Weld Re-5J School District
2020-24 Capital Construction Program
110 Centennial Drive, Unit A
Milliken, CO 80543

ADDENDUM #1

TO: Weld Re-5J School District, Professional Land Survey Services
RLH Engineering Project Number 20080

SUBJECT: Addendum Number One

NW HIGH SCHOOL – SITE PLAN

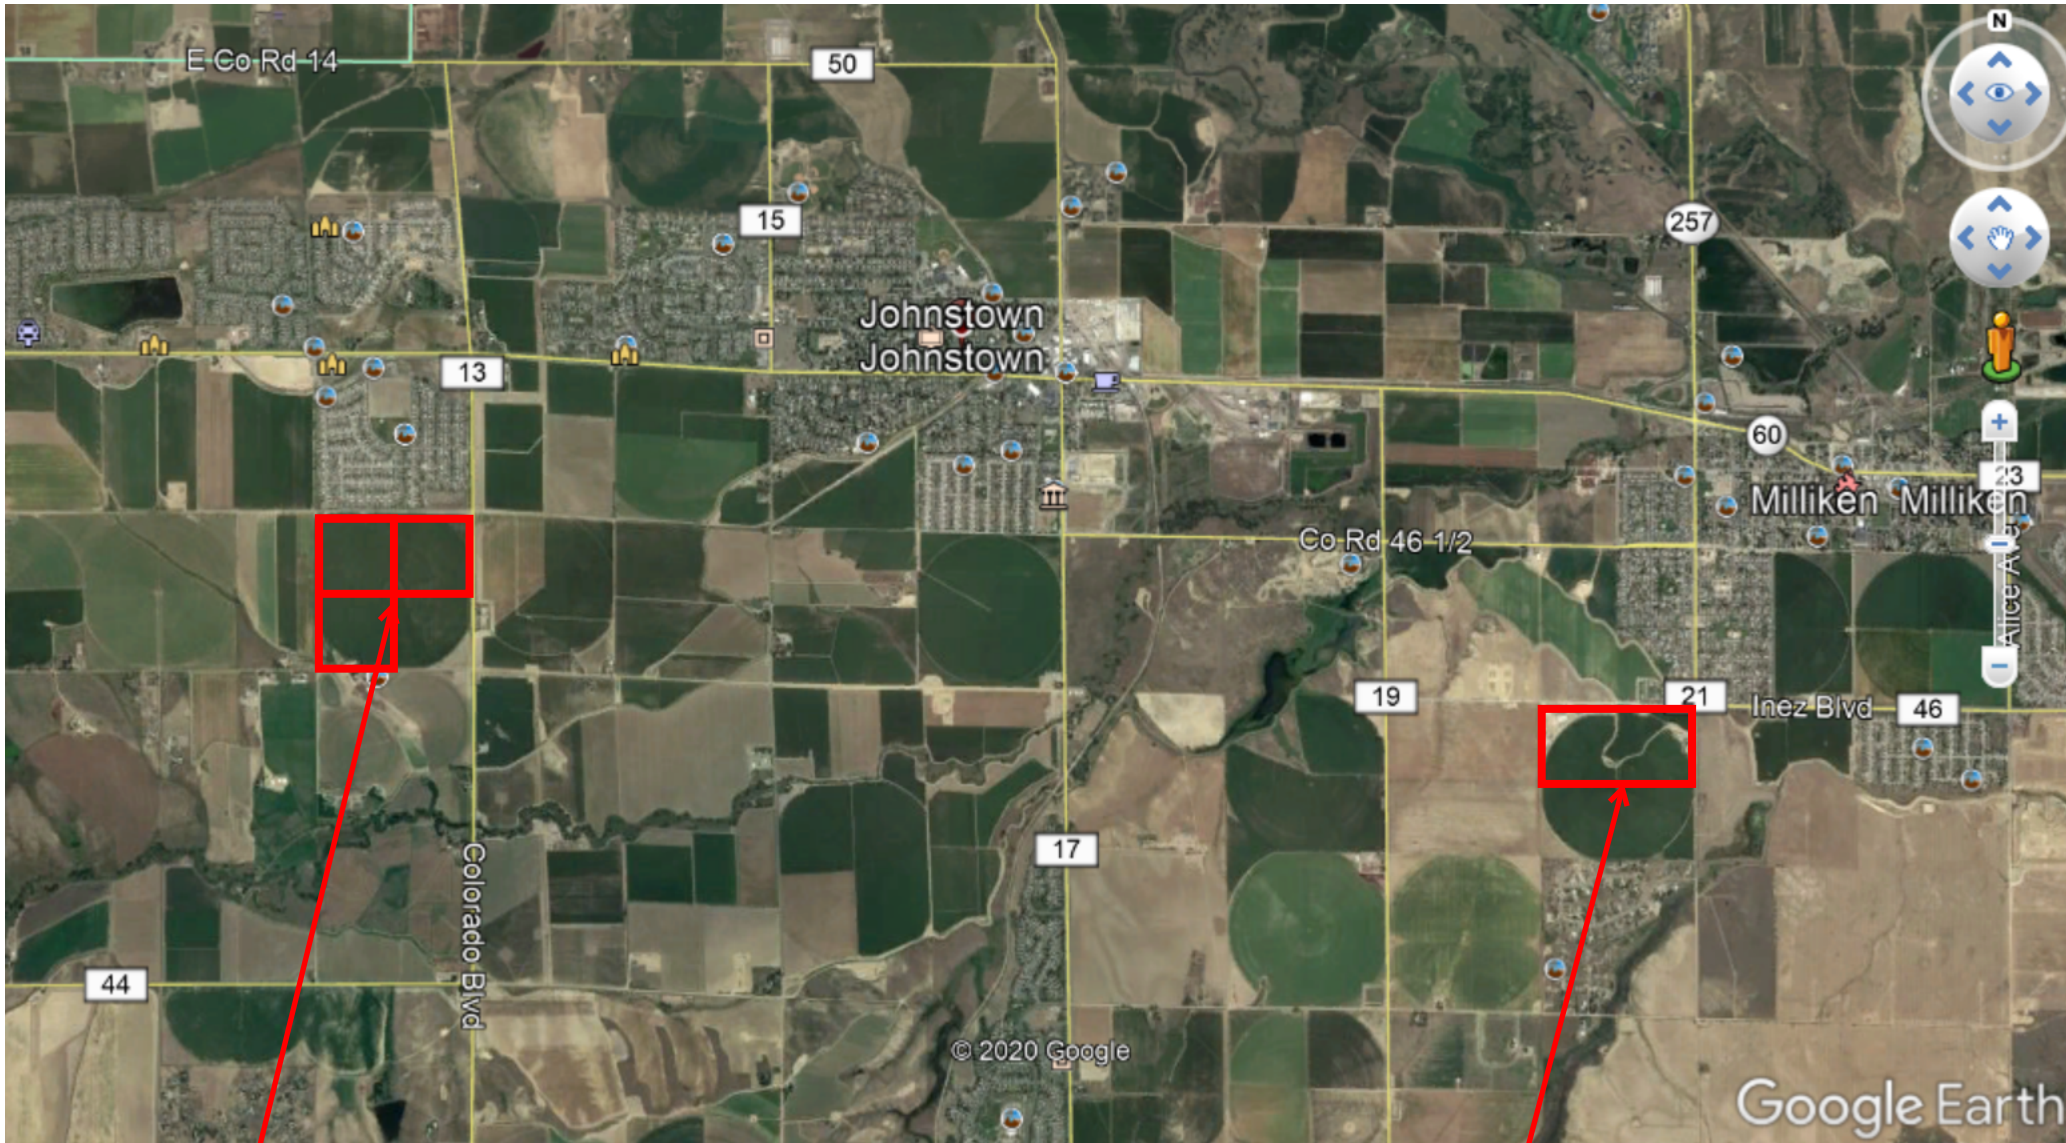
1. Question: The description (of the High School Parcel) calls for about 80 acres, the area depicted on the provided pdf is about 120 acres and the parcel owners by Sauer is about 160 acres. Can we clarify the boundary of this one?

2. Question: It appears to me that the Site #1 (for the new HS) has the potential to be 2 different parcels fronting on Inez Blvd & WCR 21. Could you verify which Section we might be looking at. Also, if it is the parcel on the East side of WCR 21, it would be a subdivided parcel. Is this a correct assumption?

3. Question: Is Site #2, the Sauer Whitehall parcel, the parcel directly south of the Clearview Subdivision? If so, should I be estimating the cost to survey the entire Quarter Section they currently own or just half of the Quarter Section. I would assume that if it is intended to just survey one half of the Sauer Whitehall parcel, it would be the East Half along Colorado Blvd. Is this a correct assumption?

Response: We are requesting proposals for a full survey to property line for the approximate 120 acre Lot Holdings parcel and the approximate 160 acre Sauer Whitehall parcel. We anticipate that the final site selection and layout will use approximately 80 acres of one of the parcels, but until the design work progresses, the location for the new High School is undetermined.

Answer: The parcel under consideration in the Milliken area is Parcel No. 105915000029. At the early stages of a site test fit, we believe the best location for the New High School would be fronting Inez Boulevard to the North and encompass the north half of the parcel. This concept would preserve the south half of the site as future residential development as currently Platted with Milliken (Pheasant Hills Filing). This RFQ/P is requesting for a survey of the entire parcel so that the design team can explore all options as we make our final site selection and subsequent design. There is no work contemplated on the east side of County Road at this time.

Answer: Yes, the Sauer Whitehall parcel is the parcel south of the Clearview Subdivision. As described above, we are requesting proposals to survey the entire Parcel No. 106112000013 to determine the best site fit for the New High School.
